**Chapter 15.80 of the Newport Beach Municipal Code
“Application for an Appeal of decisions, determination or interpretation”**

Address: 7210 W Oceanfront, Newport Beach, CA, 92663

**Plan Check # 2932-2016
Building Permit # X2016-4273**

**Owners Mr. & Mrs. Reeves
Sept 30, 2020**

Exhibit 5

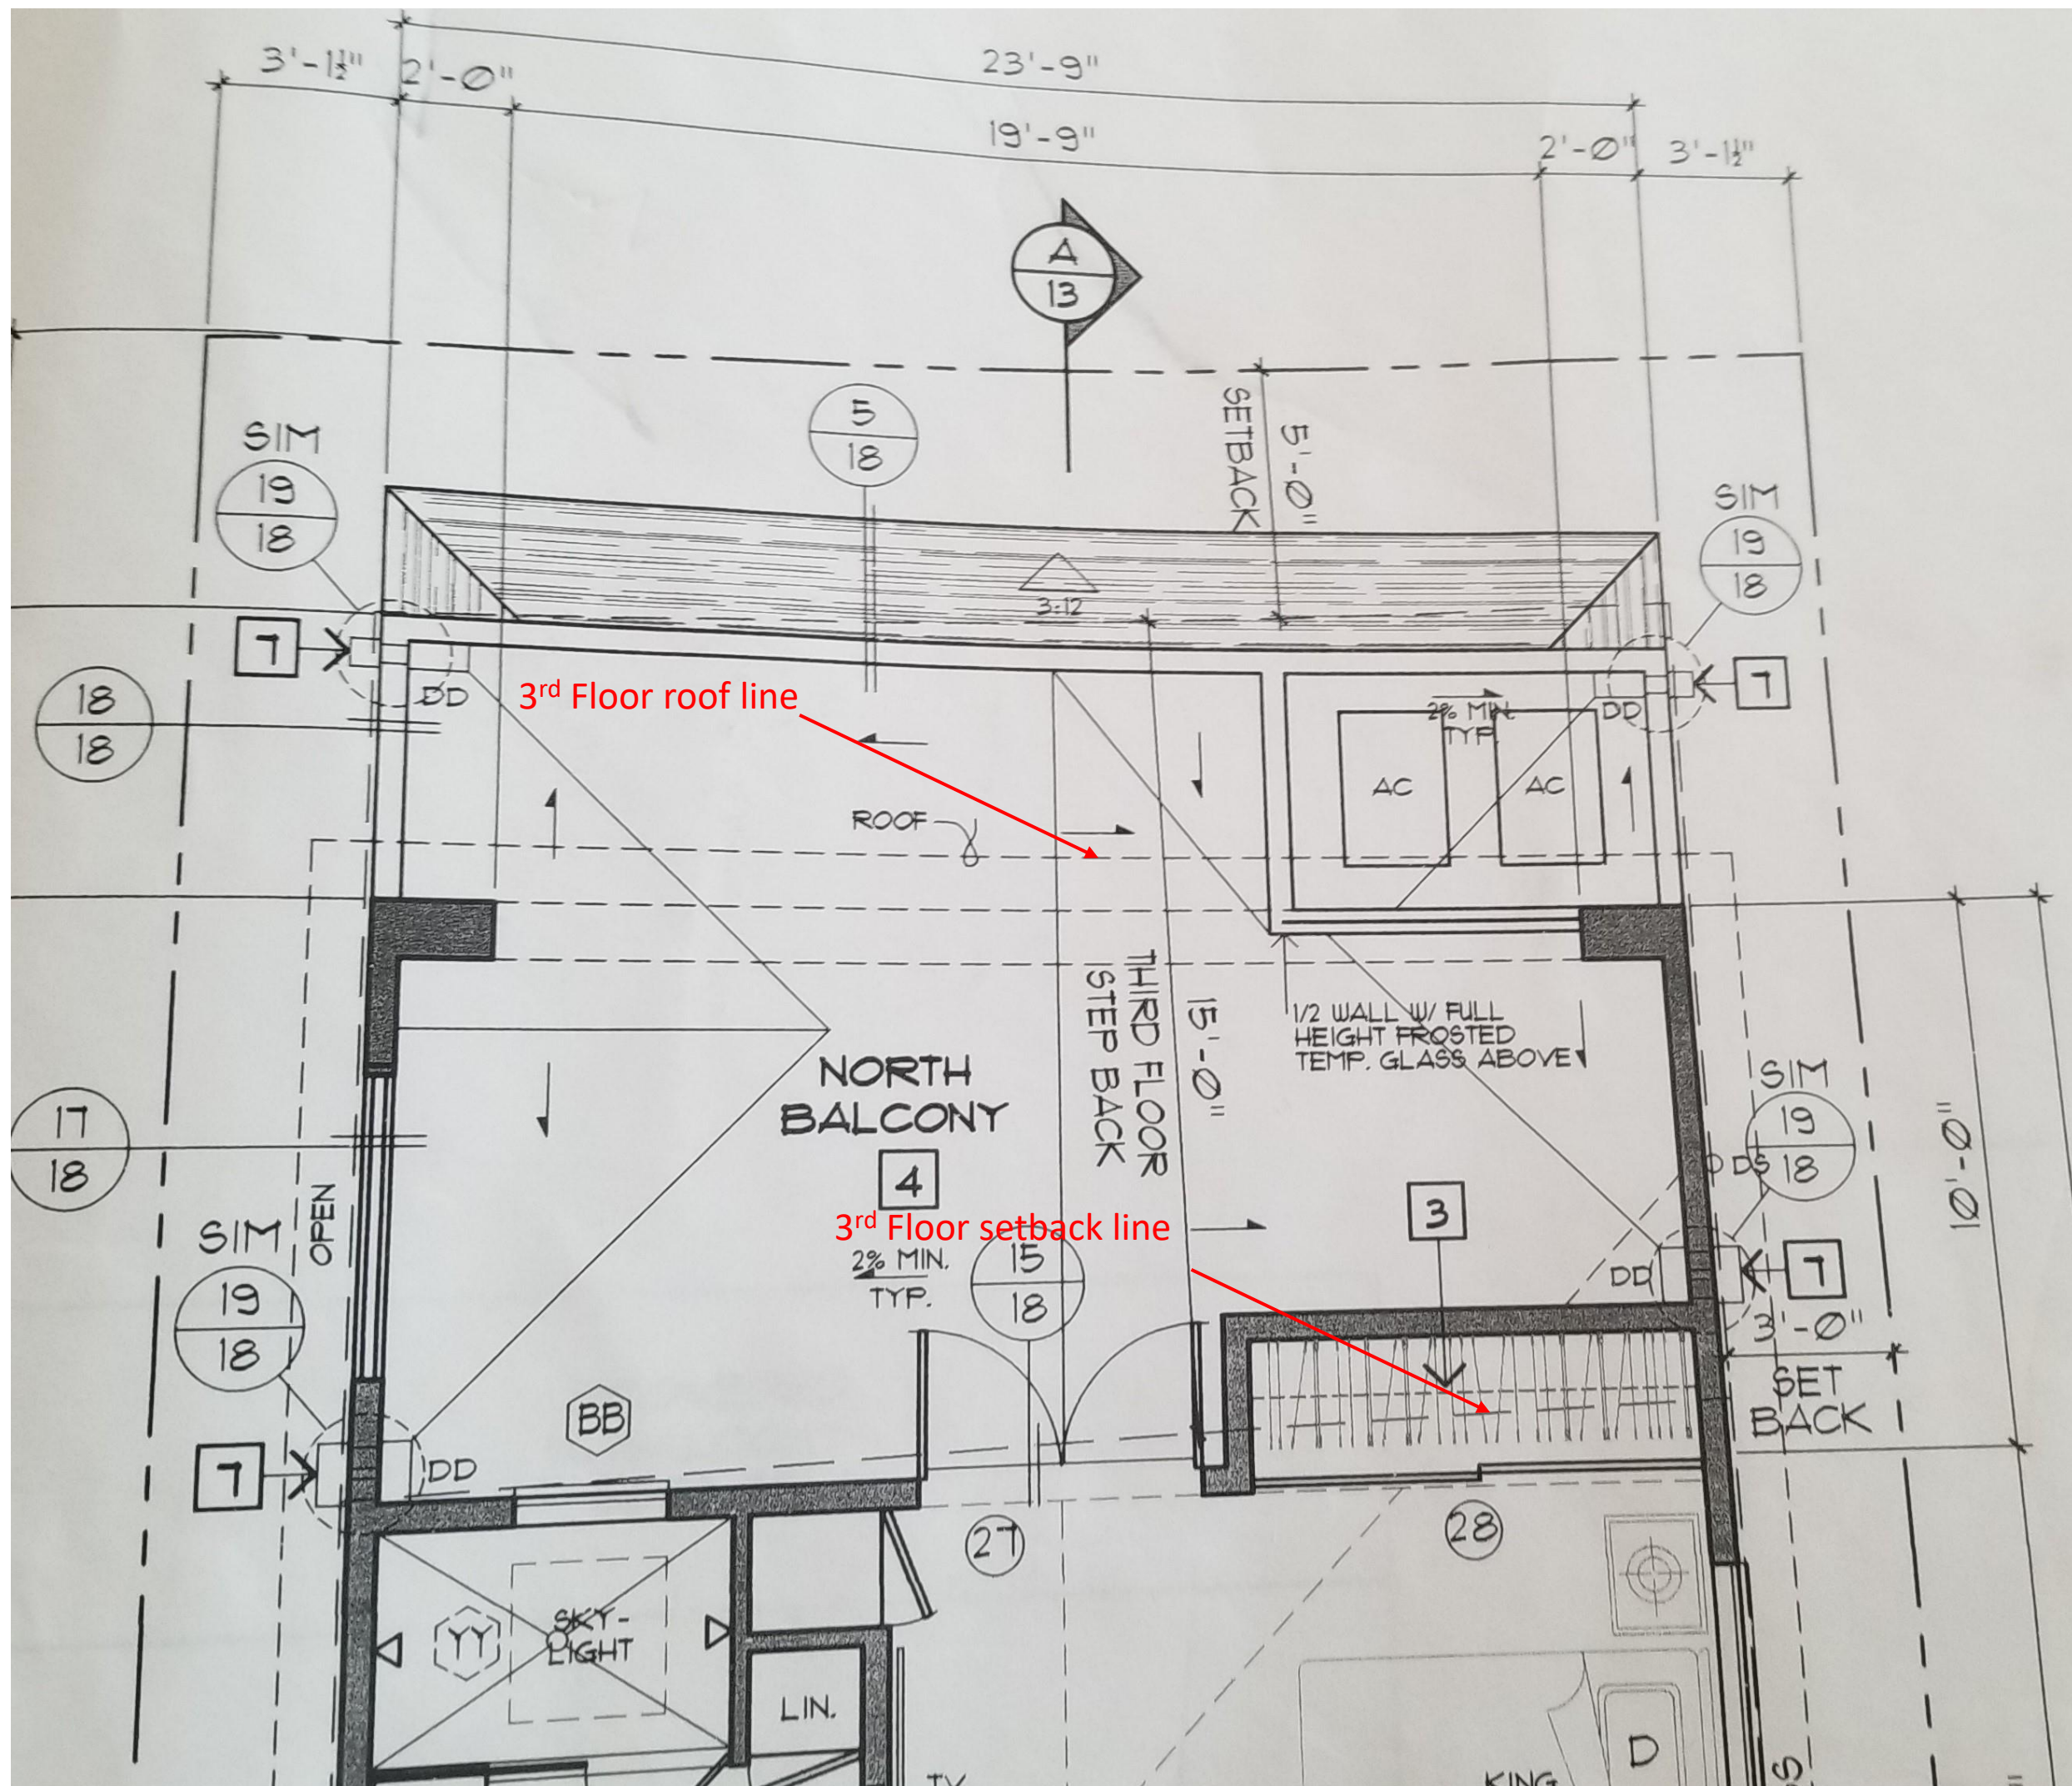
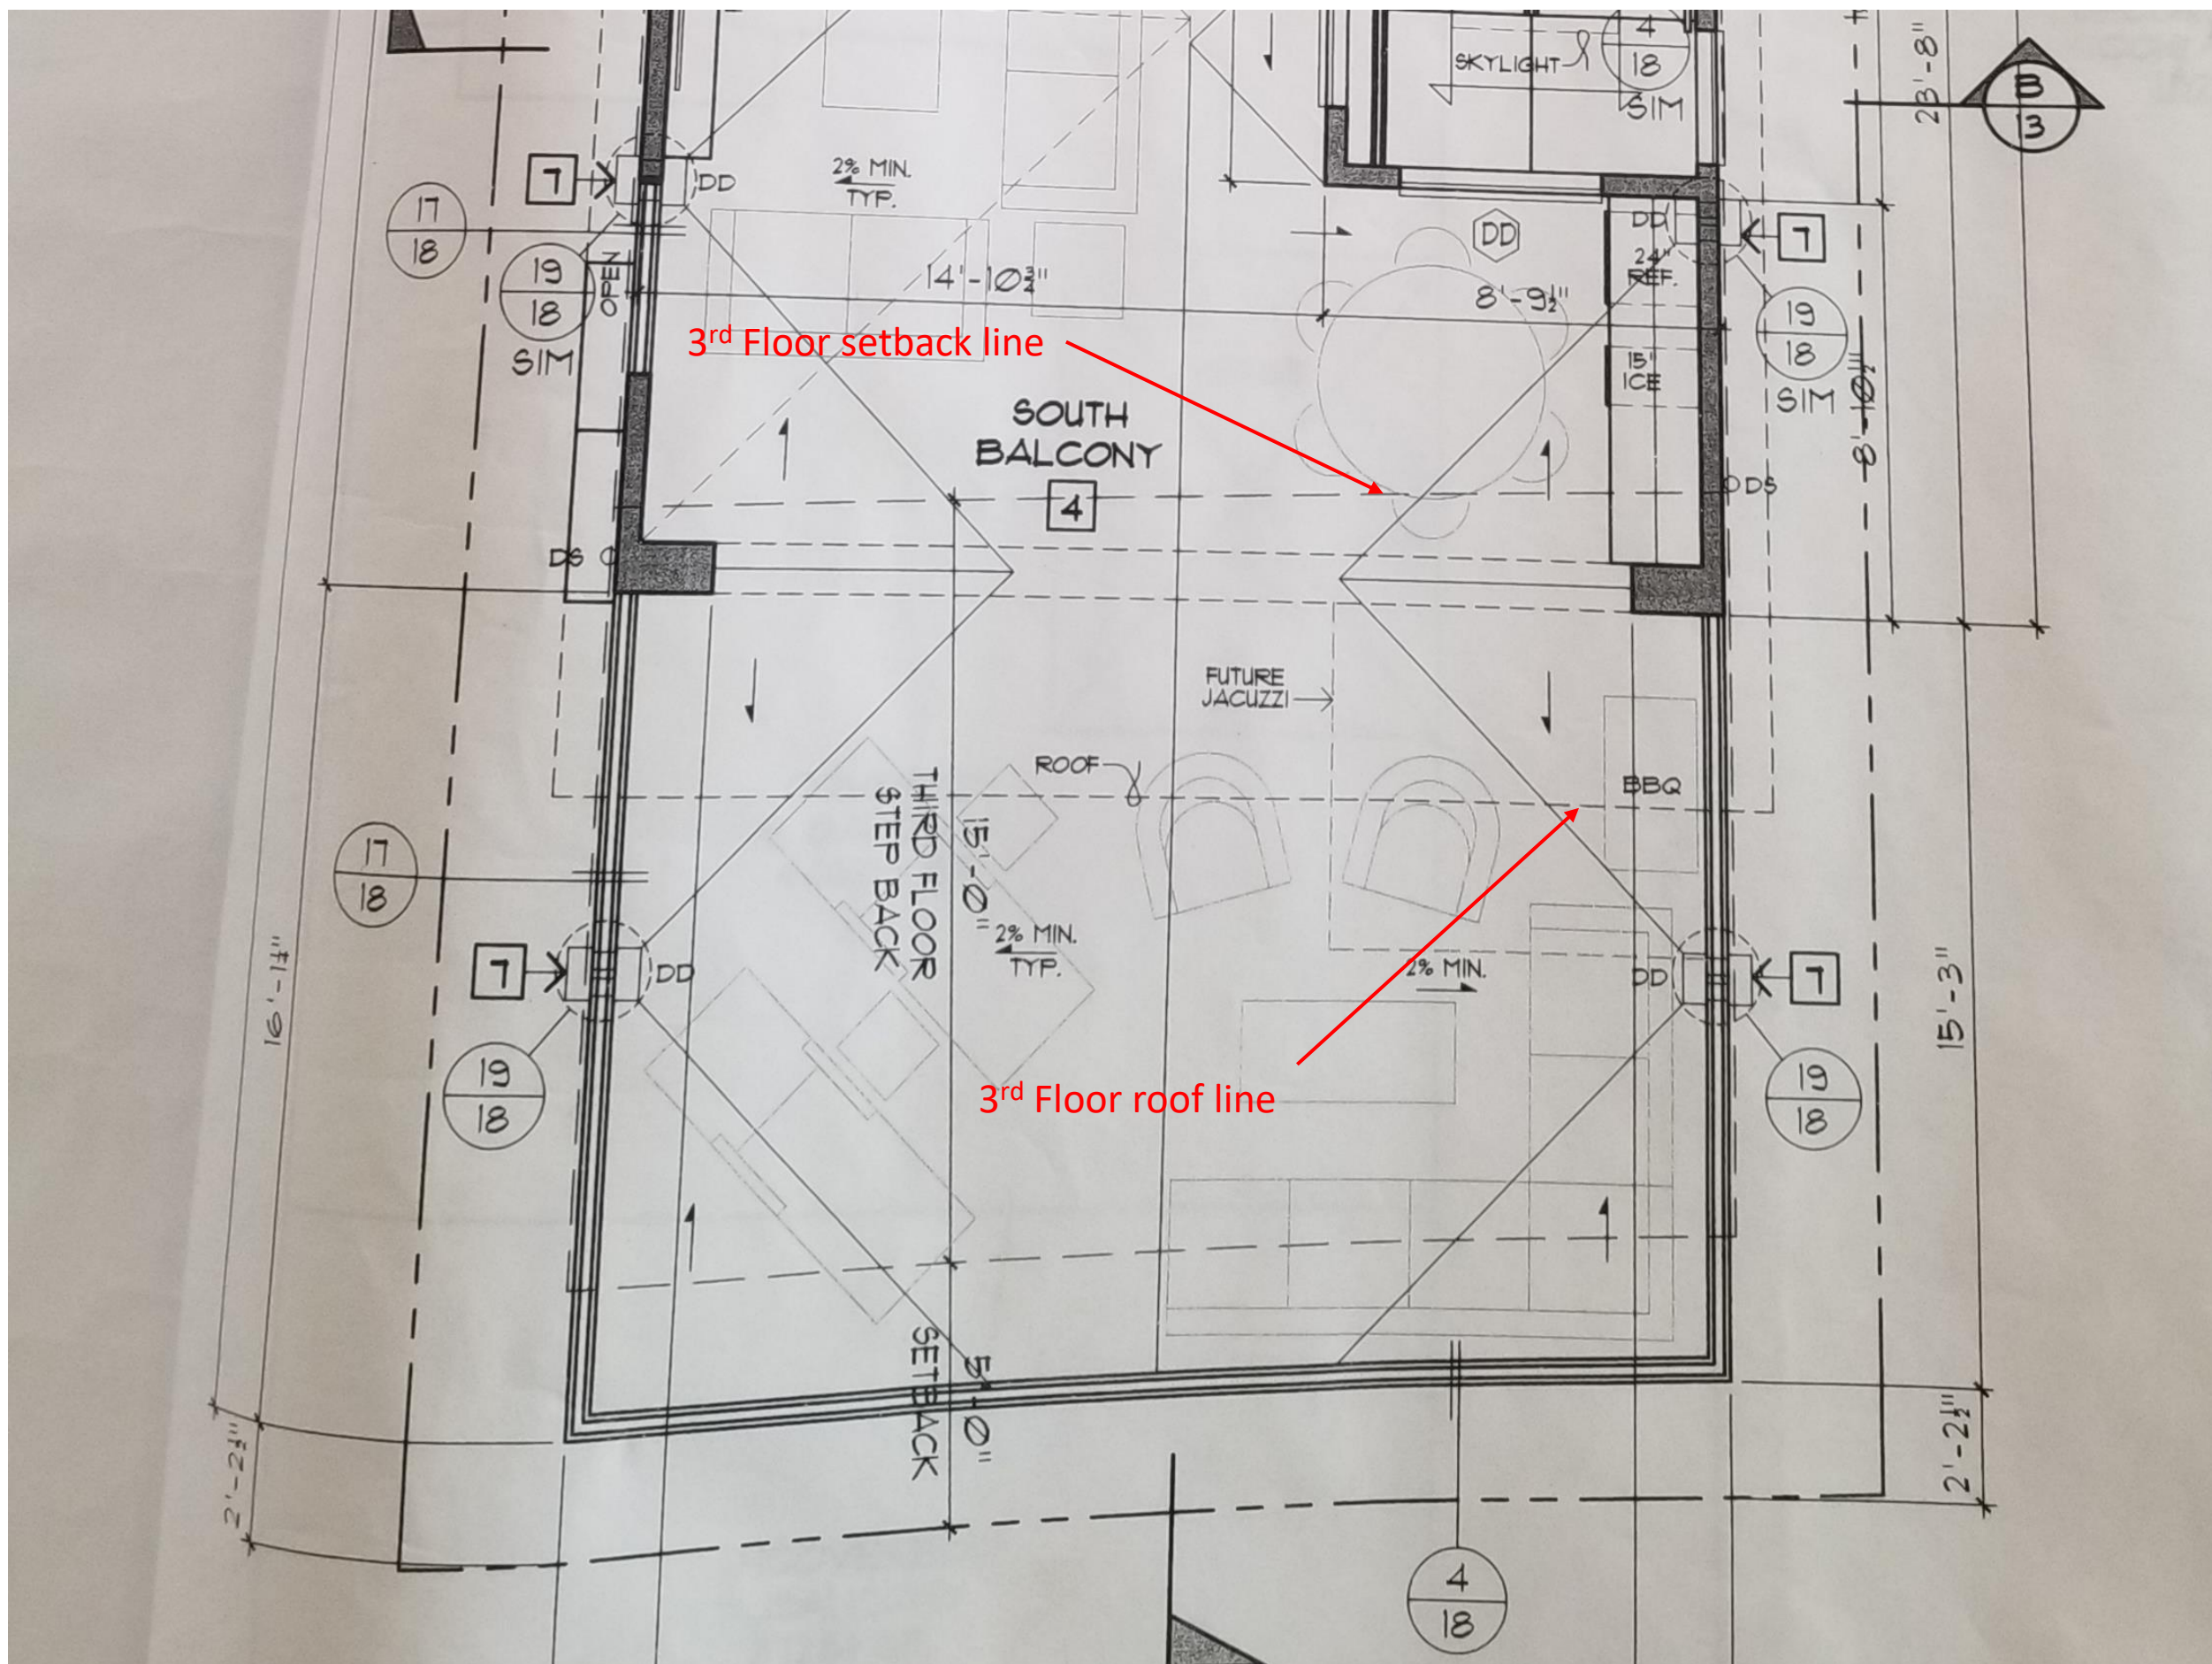
7302 W Oceanfront, City definition of NOT “Massing” or “Encroaching”. 10 FEET encroaching.

7302 W Oceanfront, City definition of NOT "Massing" or "Encroaching".

7302 W Oceanfront, City "Allowable" which is 840 square feet. NOT 312
